工程指示 / 要求簡箋(E.I.)

工程指示編號：EI / 2677 / 20

工程名稱：亞皆老街中電

工程項目：平台制房百葉地盤用鋁板 (LV SWITCH ROOM 1) LG2

名稱	鋁背板加工圖	制圖	LHR	2020.6.12	修改		
材料	3mm厚鋁板 (3003H14)	復核	-	-	日期		F150
顏色	UCT806812XL-3	批准			圖號	J852-LVA-AP1-03

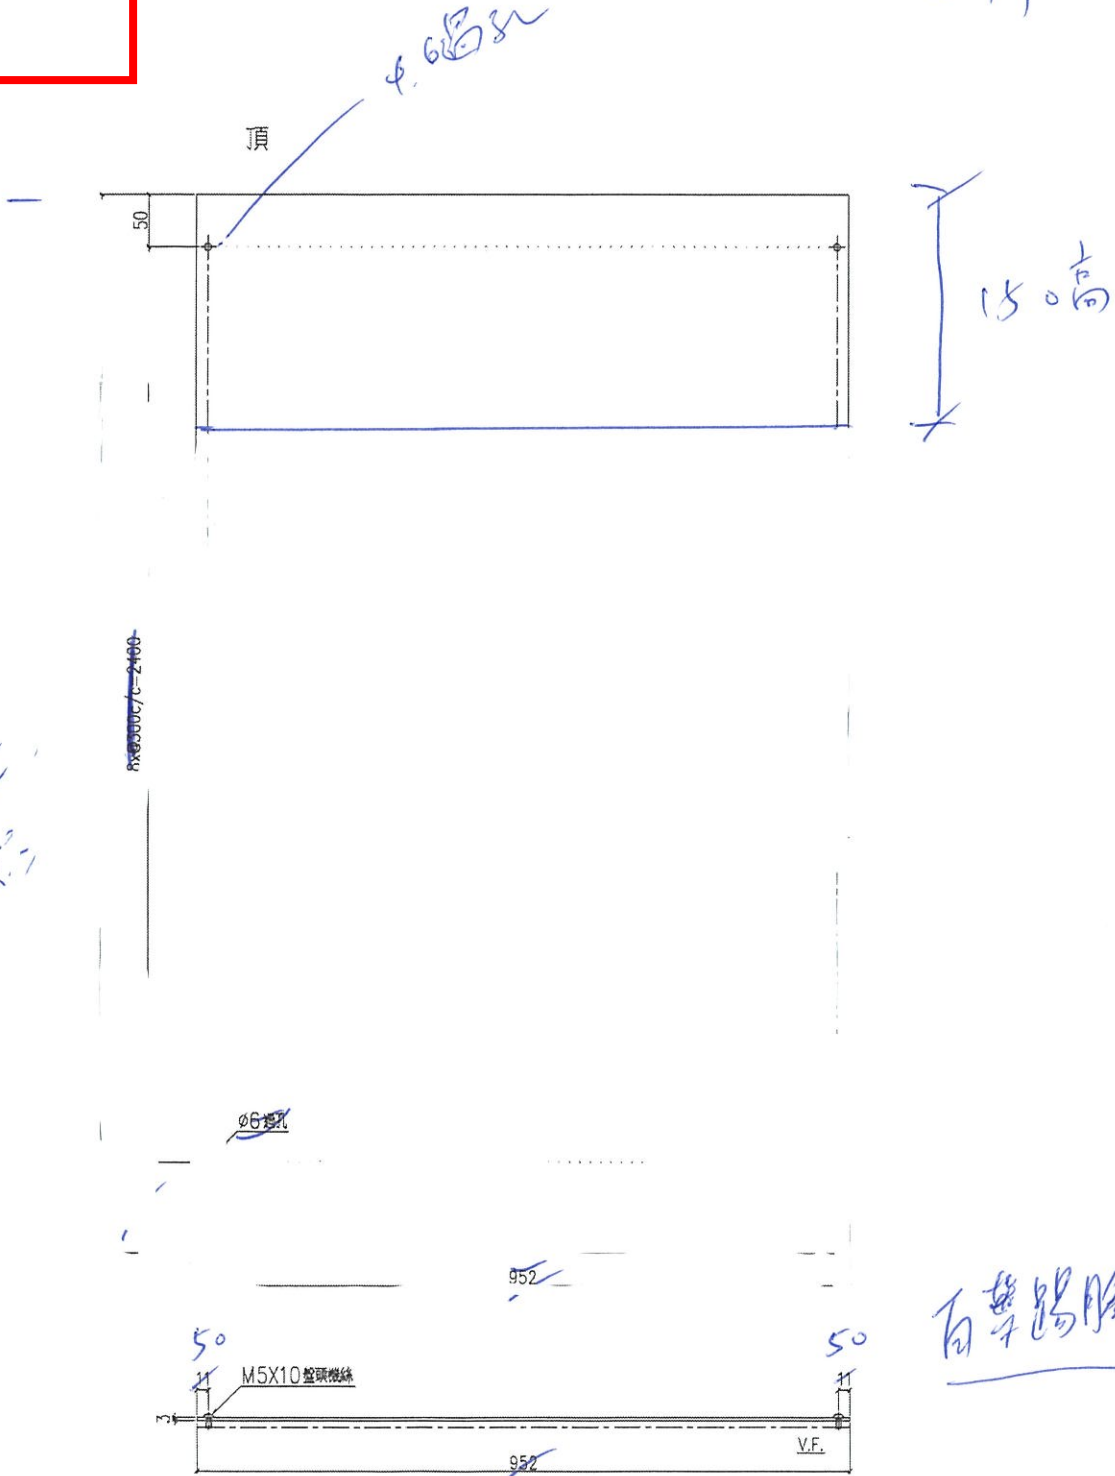
原 EI 2447，請加做樣板，謝謝

請按此加工圖生產制房百葉地盤用鋁板

踢腳板 F150 2 件

加2图 LVA-B-90

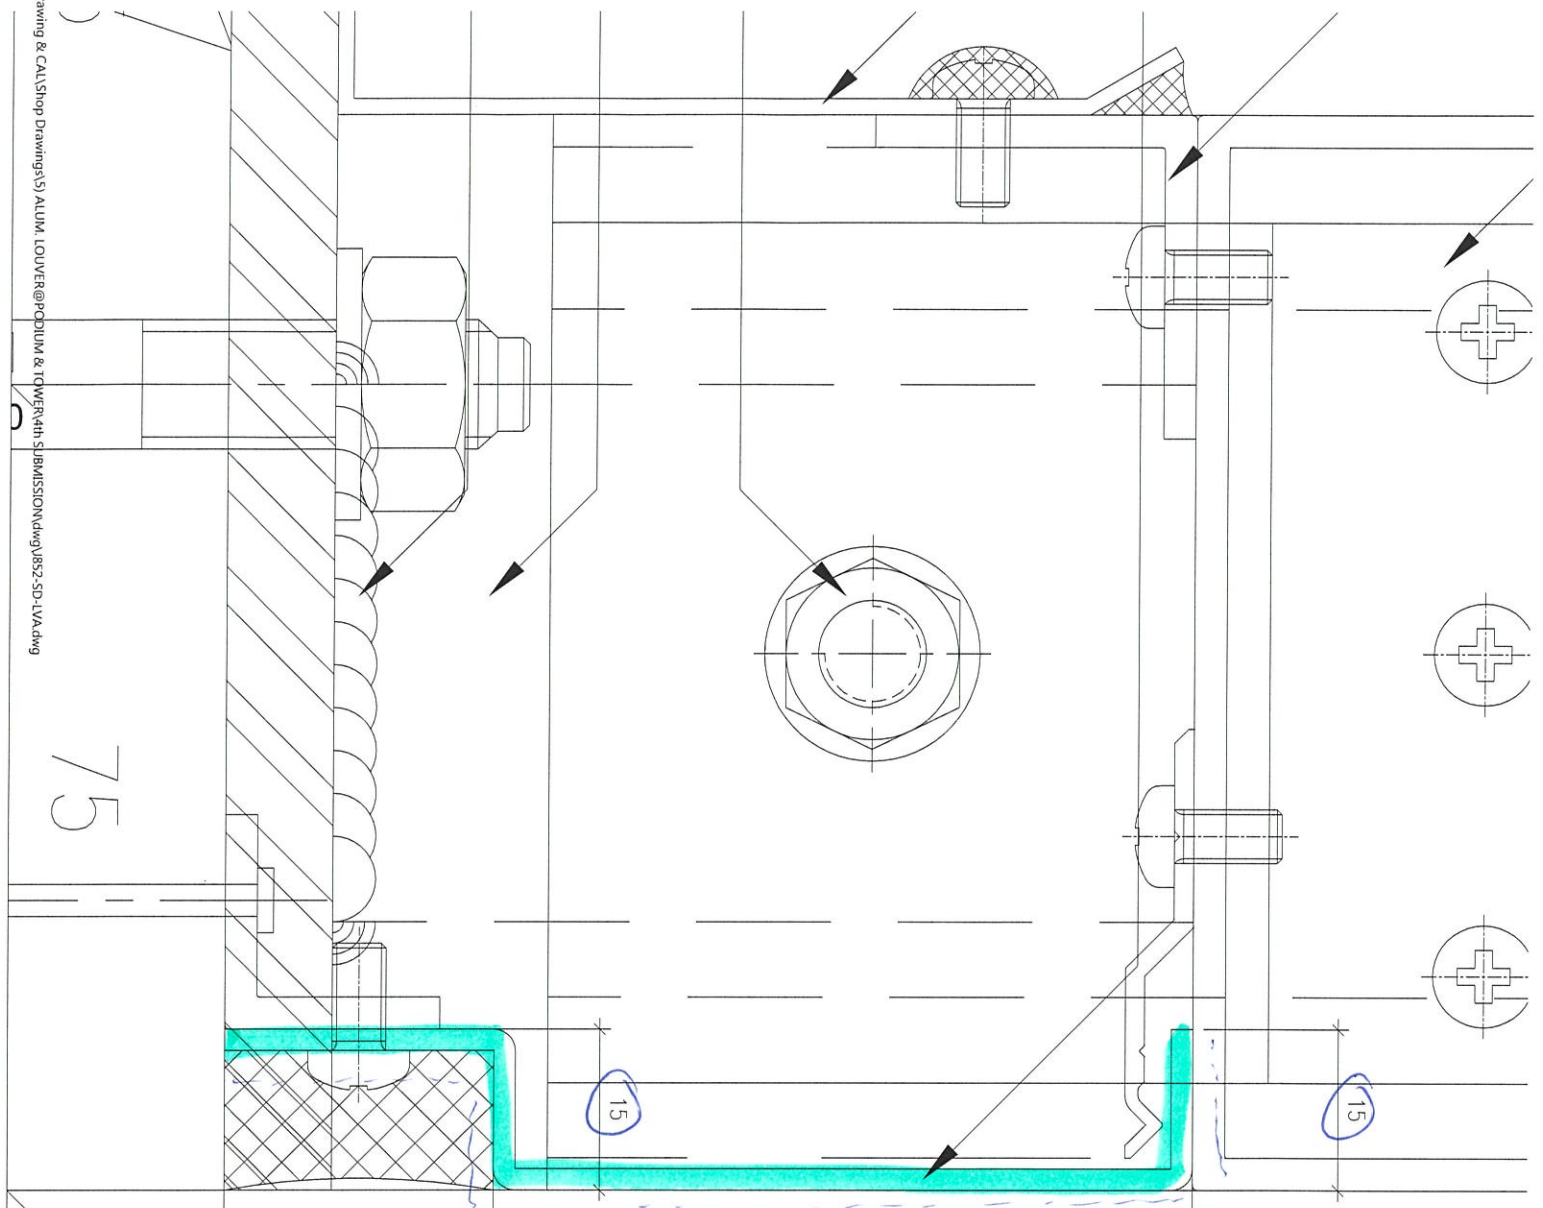
收口鋁板 LVA-B-90 2 件

LG2/F LV Switch Room

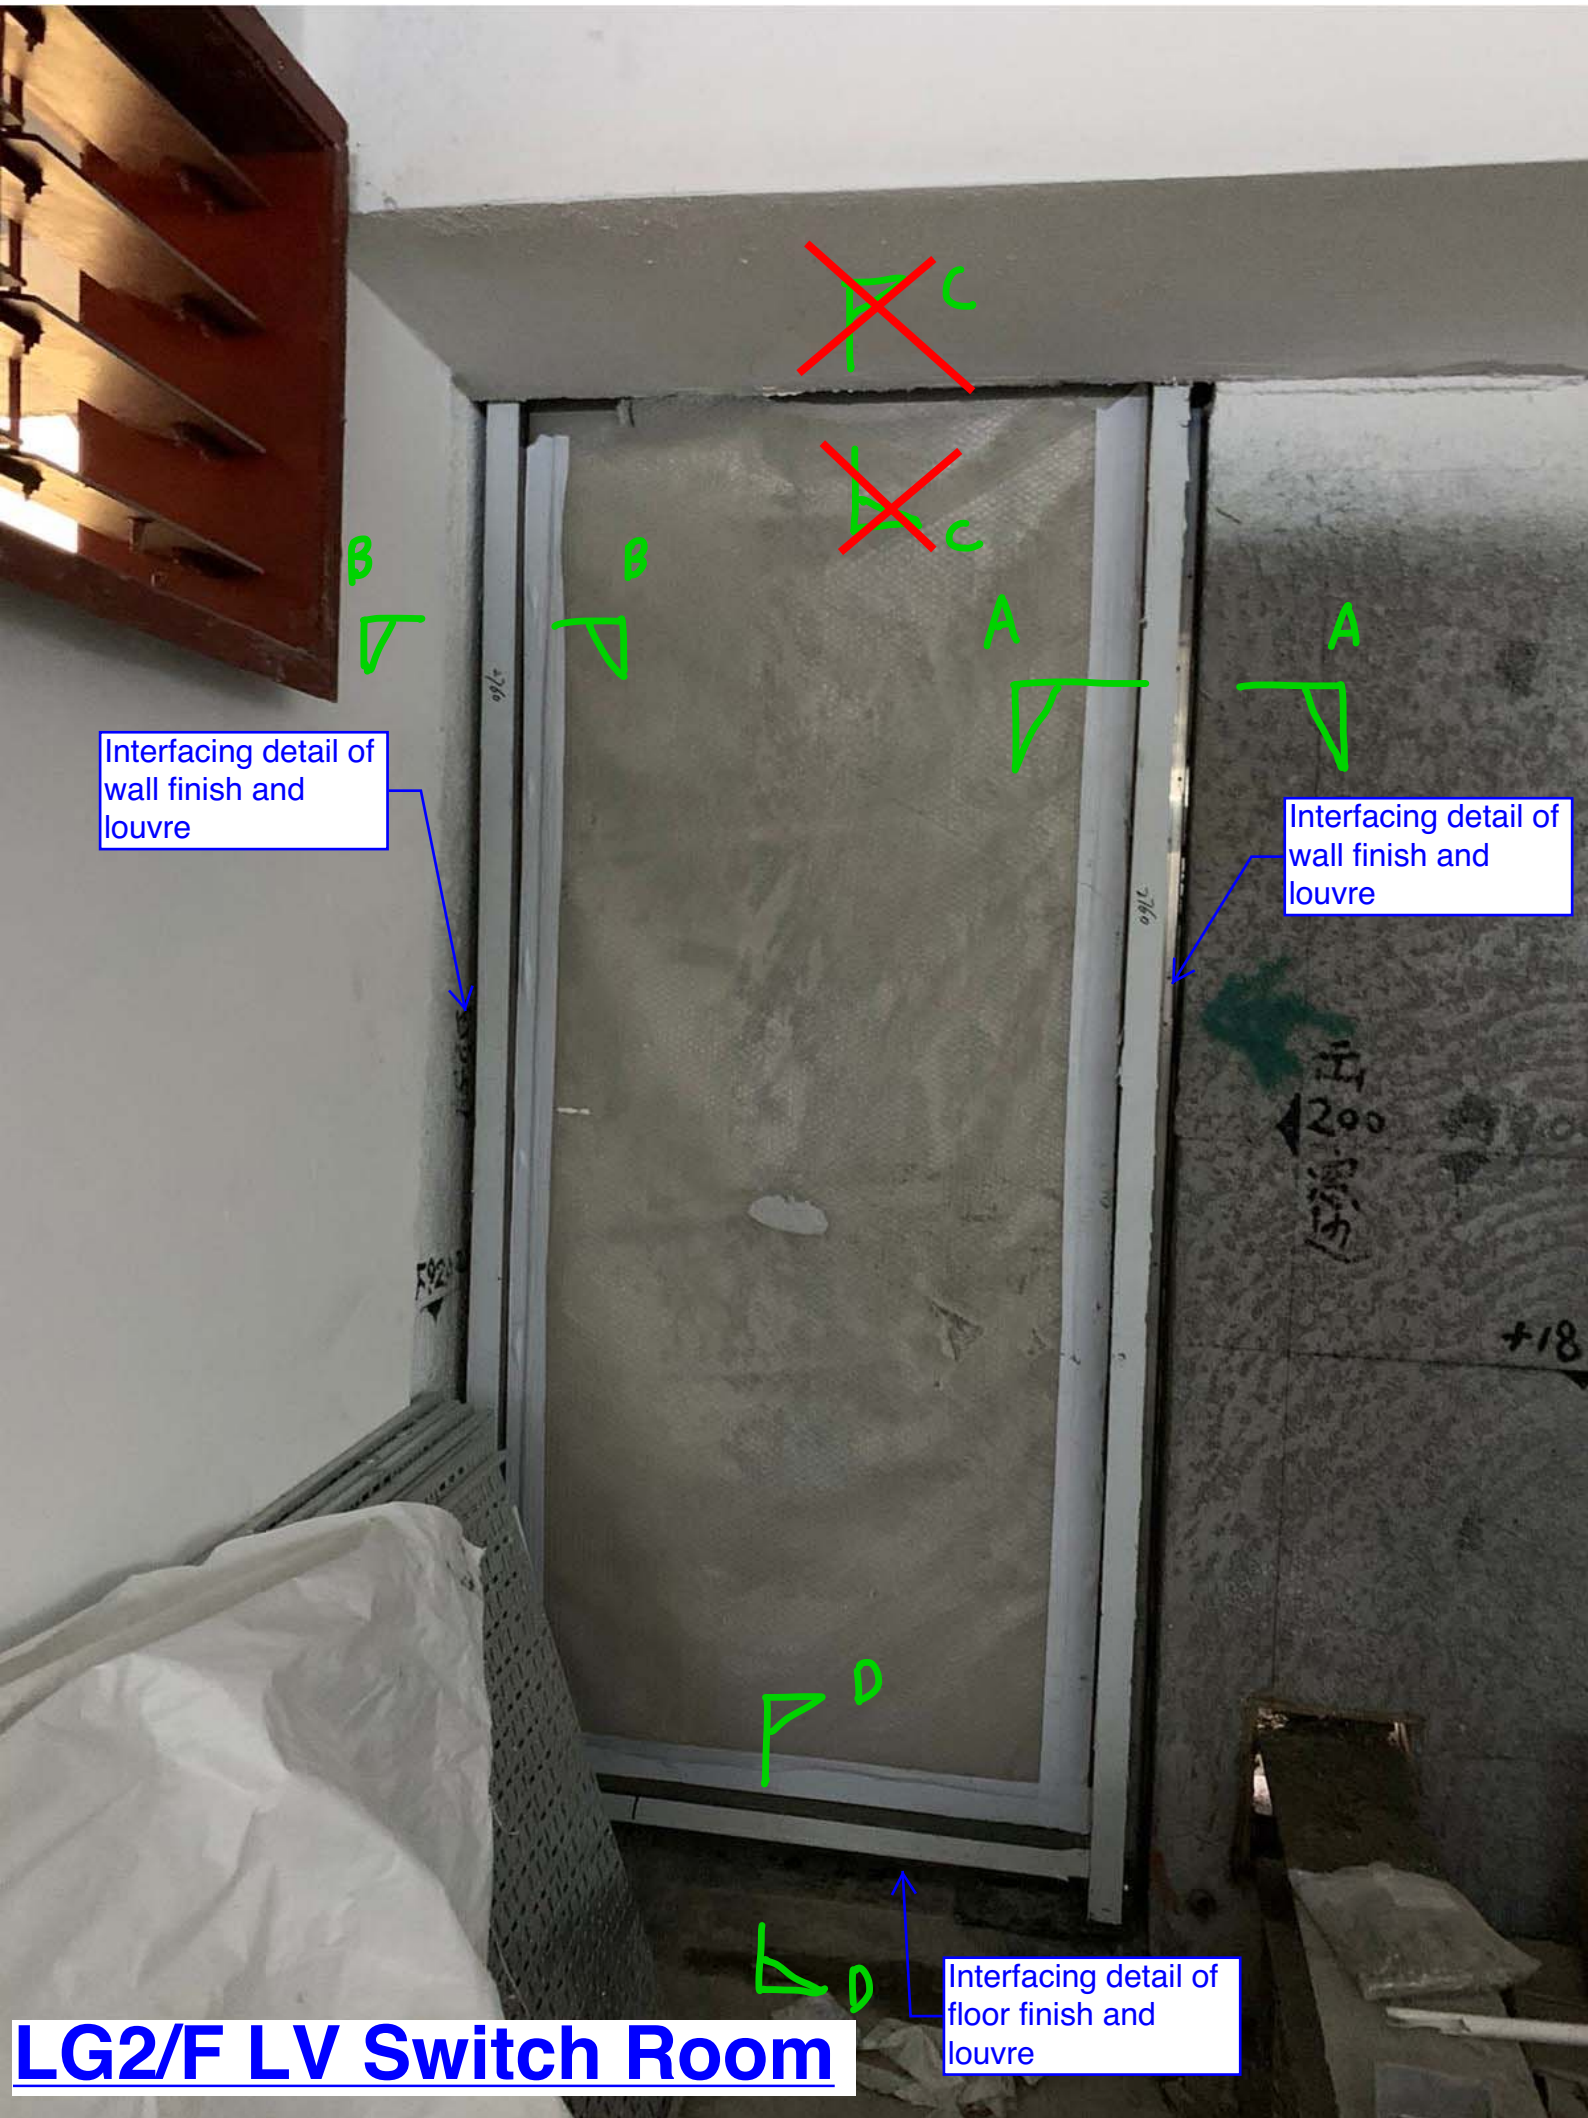
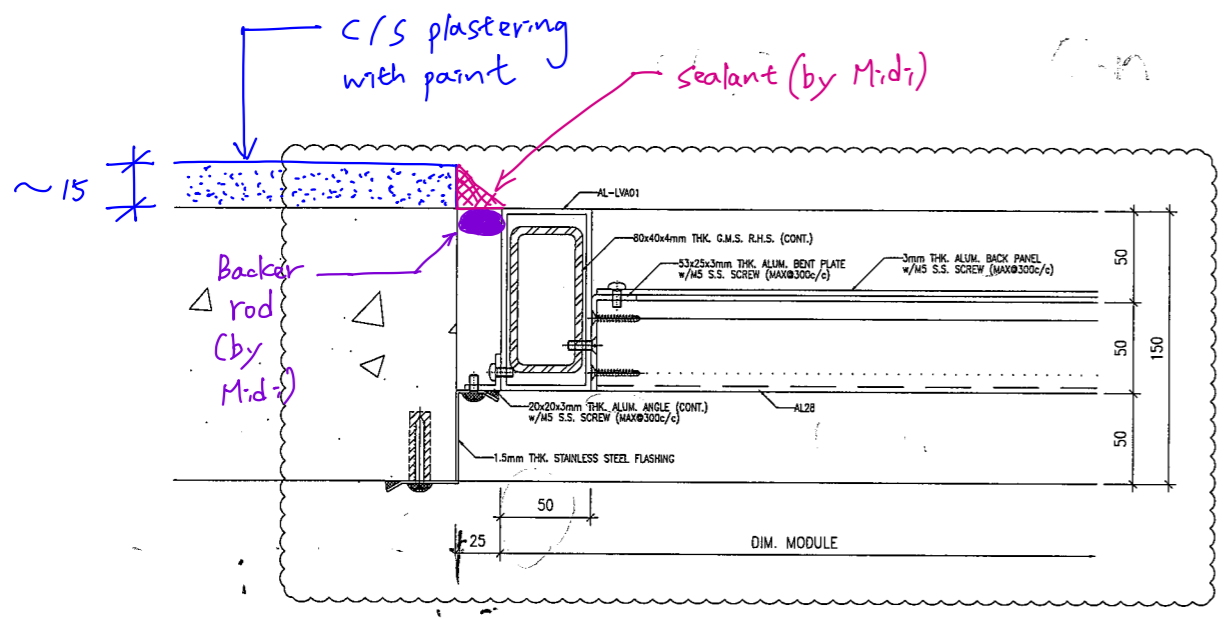
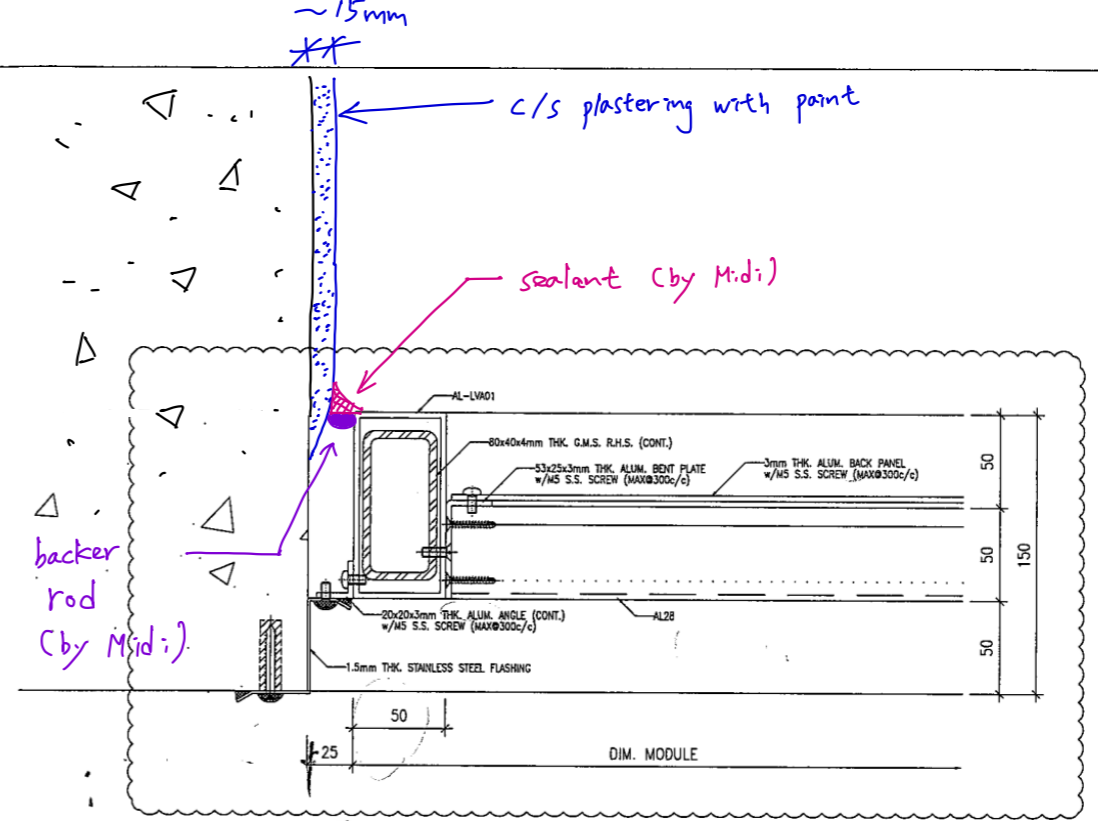
For the top part, no interfacing details provided as there is R.C. beam at the top of louver with reference to the attached drawing.

Moreover, we suggest that grouting is not necessary as flashing is added for four sides of louver for waterproofing.

Please note that flashing is added but no grouting for louver at podium with reference to the attached drawing. Please kindly review the waterproofing issue.

How about the top part? Most of the rooms with external louvre will not have false ceiling and louvre top fixing should be sealed up with the details same the one you proposed for bottom part. All four sides of the louvre need to be sealed up at the interfacing with wall opening. Besides, you better seek approval from Sino as this kind of interfacing detail without physical grouting is not a common detail in terms of waterproofing. Regards, Raymond Ho何耀威 Associate Director
助理董事 AGC Design Ltd
www.agcdesign.com.hk<<http://www.agcdesign.com.hk>> 16/F Olympia Plaza 255 King's Road Hong Kong 香港北角英皇道二五五號國都廣場十六樓 (D) 852 25088381 (T) 852 22197188 (F) 852 22197133 (E) raymondho@agcdesign.com.hk<<mailto:raymondho@agcdesign.com.hk>>

Further to AGC and MFT' s reply yesterday, we will proceed internal finishing works as per attached detail accordingly.

If the interfacing at top part happens to all louvres at Podium that facing Argyle Street, I have no other comments.
